PCN no.: PCN-111 rev. 1.0	Date: 2018-11-21	
Device affected: nRF52840-QIAA	Device version / Build Code: C00	
Data sheet references: N/A	Agreement reference: N/A	Customers reference: N/A

Description of change:

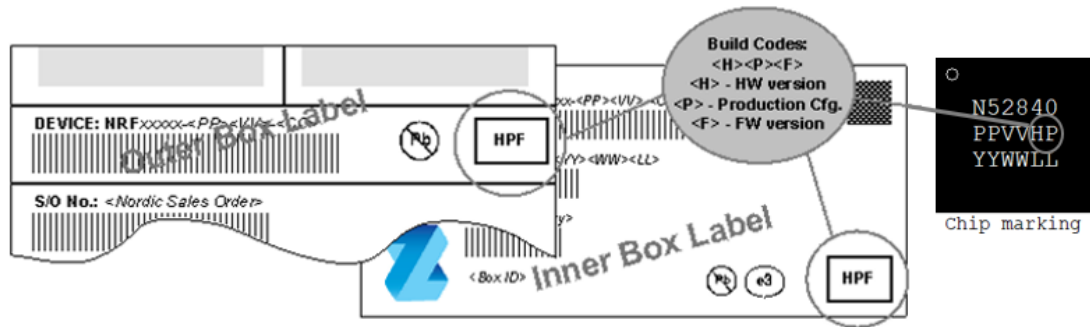
The new device version is software compatible with the current version if using SDK15.0/15.1 and SoftDevice S140v6.0.0/6.1.0 but note that these versions have implemented workarounds for Errata-192 and Errata-201 which will be executed without impact on function on this device version.
